RE: Denial to enclose Second Story Porch

RE: Application for Special Permit – 59 Selwyn Road

PROPOSED ADDITION AND RENOVATION TO  
**THE LAVOIE RESIDENCE**  
 59 SELWYN RD.  
 BELMONT MA.

PROPOSED PLOT PLAN  
#59 SELWYN ROAD  
IN  
BELMONT, MA  
(MIDDLESEX COUNTY)

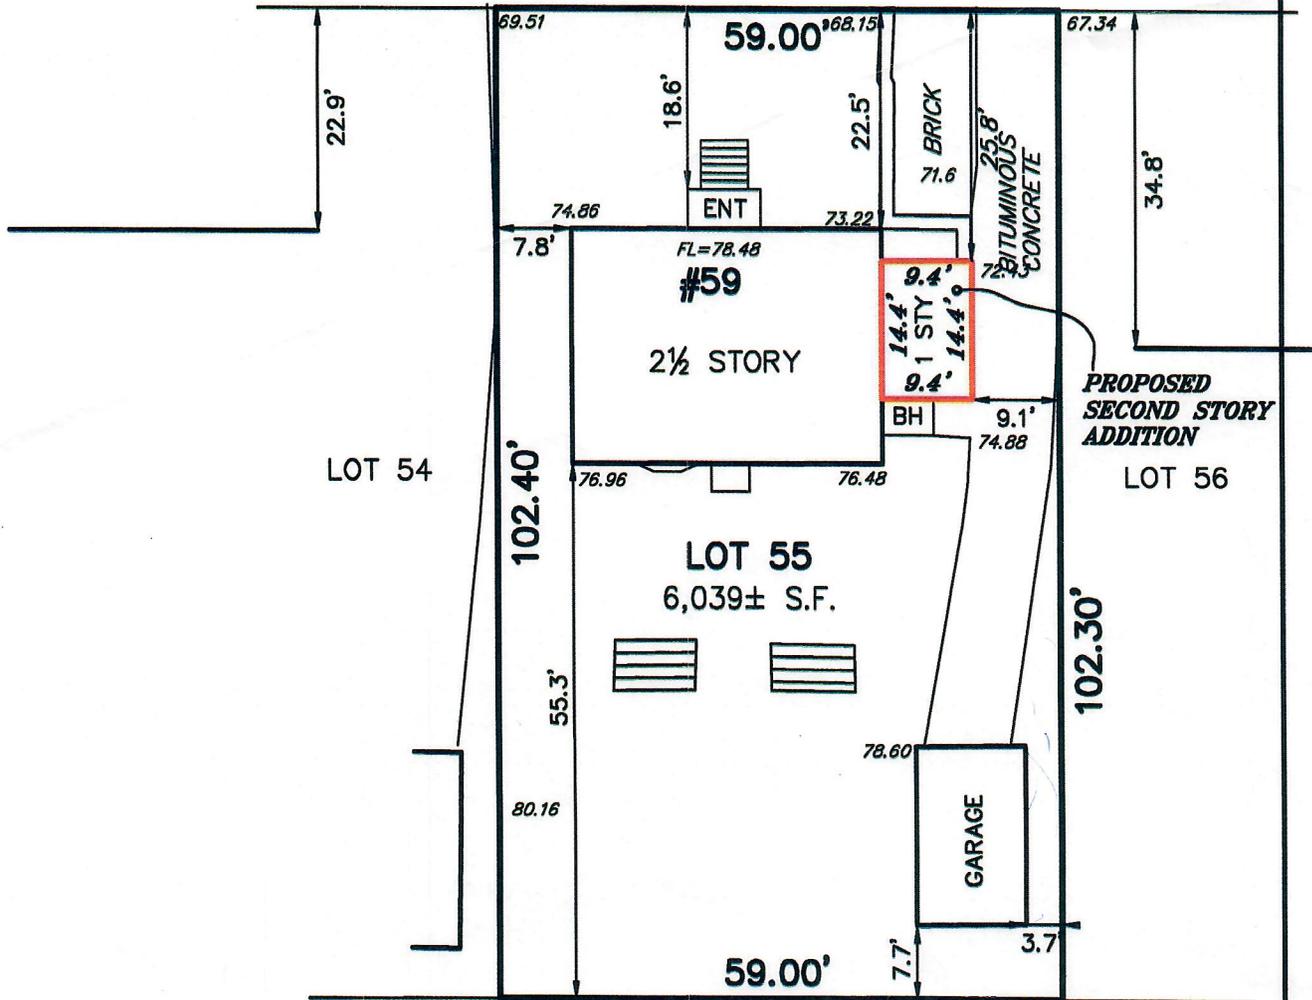
Your application has been denied because it does not comply with the current Town of Belmont Zoning By-Law. More specifically, Section 4.2.2 of the Zoning By-Law Dimensional Regulations requires a minimum side setback of 10.0'.

1. The existing and proposed setback is 9.1'.

You may alter your plans to conform to the current Town of Belmont Zoning By-Law and resubmit a building permit application, or you may request one (1) Special Permit from the **Zoning Board of Appeals**. If you choose this option, please contact the Office of Community Development to schedule an appointment with **Gabriel S. Distler**, Staff Planner, at (617) 993-2666 or [gdistler@belmont-ma.gov](mailto:gdistler@belmont-ma.gov) in order to begin the process.
